### **VAILS GATE FIRE DISTRICT**

**New Storage Building (Phase I)** New Fire Station (Phase II)

MARK	DATE	DESCRIPTION
2	12/22/2022	REVS. PER TOWN COMMENTS

BUILDING CODE ANALYSIS &
EGRESS PLAN
NEW STORAGE BUILDING
PHASE 1

**ARCHITECTURE** SCHEDULES AND PARTITION TYPES **NEW STORAGE BUILDING** PHASE 1

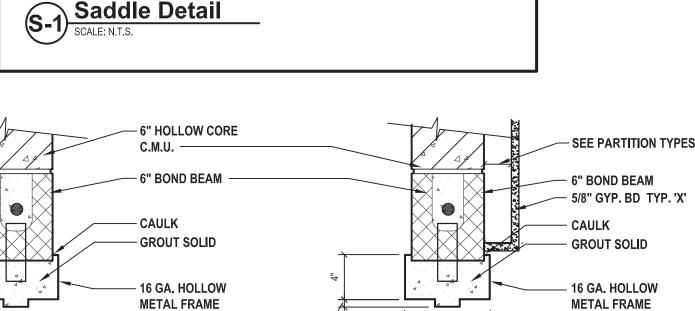
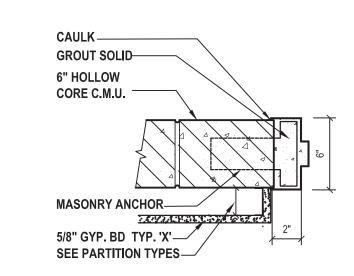
R-Values removed from plans- only shown on Comcheck and specifications
